Eraring Battery Energy Storage System

Response to Submissions
3 March 2022

Origin
SSD-15950052

Document no: IS365800_Eraring BESS_RtS
Revision no: Final

Figure 4-1 Aerial 1979

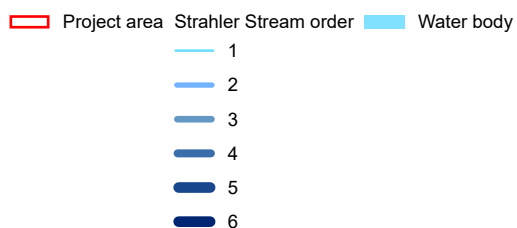
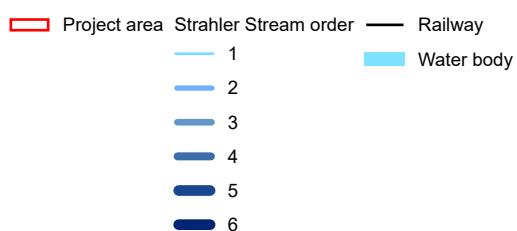
DPE Water and the NSW Natural Resources Access Regulator (NRAR) sought more detail on characteristics of the riparian corridor in the two first order watercourses that will be removed and an impact assessment to the downstream environment. This is to ensure compliance with the *Guidelines for Controlled Activities on Waterfront Land* (NRAR, 2018) and to determine if any mitigation measures should be put in place.

The mapped first order watercourse in the southern portion of the Project area would not be removed or disturbed as part of the Project and would be protected. The mapped first order watercourses in the Project area have previously been modified or removed as part of the Attemperation Dam project and original construction of the EPS as illustrated in **Figure 4-1** and **Figure 4-2**. As shown in Figure 4-1, the downstream second order watercourse was diverted at the time of construction of the EPS. At the same time, the first order watercourses within the Project area also experienced significant disturbance within their catchment with subsequent modifications occurring due to the construction of the high level Eraring Inlet Canal (not yet constructed in 1979 aerial image). Figure 4-2 further illustrates prior disturbance of mapped first order watercourses within the Project area associated with borrow-pit and stockpiling of materials as part of the approved Attemperation Dam project.

No changes are proposed to the downstream environment on the basis that no increase in peak discharge velocity is expected, and the Project would achieve the water quality performance outcomes and mitigation measures (SW1, SW2, SW3, SW4, SW5, SW6 and SW7) provided in Appendix B.
